**Subject: PG&E Follow-up Comments on the July 16, 2008 TV workshop;
RE: 2008 Rulemaking on Appliance Efficiency Regulations;
Docket No. 07-AAER-3-C; Televisions**

The Consumer Electronics Association (CEA) gave a presentation to the CEC during the July 16, 2008 Efficiency Committee Workshop. The following pages show comments from the CEA presentation, followed by PG&E’s response.

Figure 3. CEA Presentation Slide 24

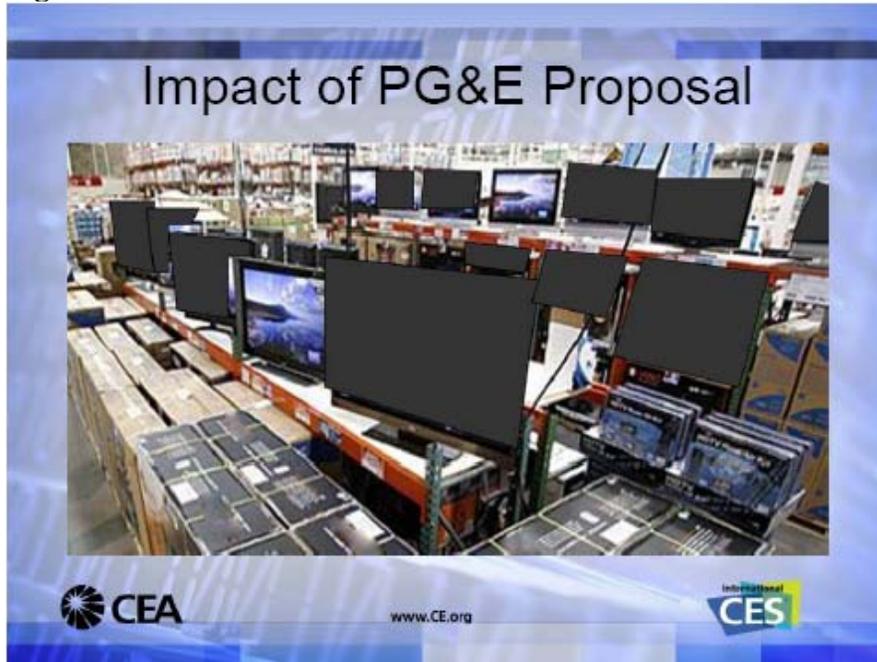
- While entertaining as a theatrical device, this slide is otherwise irrelevant and misleading. It is inconsistent with the qualification rates of TVs today, let alone those in 29 months hence.
